Access Compliance Report

Public Rights-of-Way

(Curb Ramps)

Intersection ID: 13745	Main Street: HAWTHORNE_LN	Cross Street: PARK_DR	Location: S
ADA ID: 1EA05E0ACC8E	Ramp Type: Perp	Initial Pass/Fail: Fail	Overall Compliance: No
Severity Score: 13.75			
Codes/Mitigation Info/Possible Solution		Field Measurements/Component Compliance

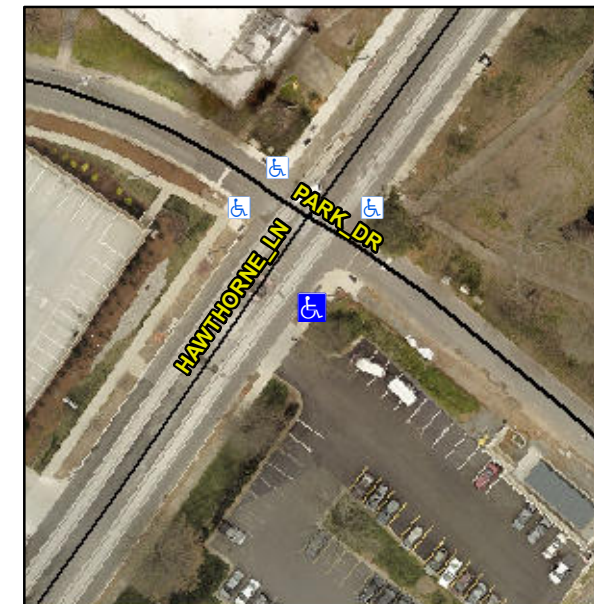
R304.2.2, R304.5.3

Compliance	Description	Data	Compliance	Description	Data
N/A	Ramp Length (in)	38.0	No	Ramp Slope (%)	10.6
Yes	Ramp Width (in)	59.5	No	Ramp XSlope (%)	4.7
N/A	Flare Type LT	N/A	N/A	Flare Type RT	N/A
N/A	Flare Slope LT (%)	N/A	N/A	Flare Slope RT (%)	N/A
N/A	Flare Traversable LT?	N/A	N/A	Flare Traversable RT?	N/A
N/A	Landing Length (in)	N/A	N/A	DWS Provided?	N/A
N/A	Landing Width (in)	N/A	N/A	DWS Contrast?	N/A
N/A	Landing Slope (%)	N/A	N/A	DWS Length (in)	N/A
N/A	Landing X Slope (%)	N/A	N/A	DWS Full Width?	N/A
N/A	Landing Curb? (Y/N)	N/A	N/A	DWS Offset (in)	N/A
N/A	Shared Landing?	N/A			
N/A	Gutter Ponding?	N/A	N/A	Gutter Slope (%)	N/A
N/A	Gutter Lip Ht (in)	N/A	N/A	Gutter X Slope (%)	N/A
N/A	Painted X Walk1?	No	N/A	Painted X Walk2?	N/A
	X Walk 1 Direction	To NW		X Walk 2 Direction	N/A
N/A	X Walk 1 Width (in)	N/A	N/A	X Walk 2 Width (in)	N/A
	X Walk 1 Slope (%)	0.3		X Walk 2 Slope (%)	N/A
	X Walk 1 X Slope (%)	3.7		X Walk 2 X Slope (%)	N/A

Remove & Replace Entire Ramp.
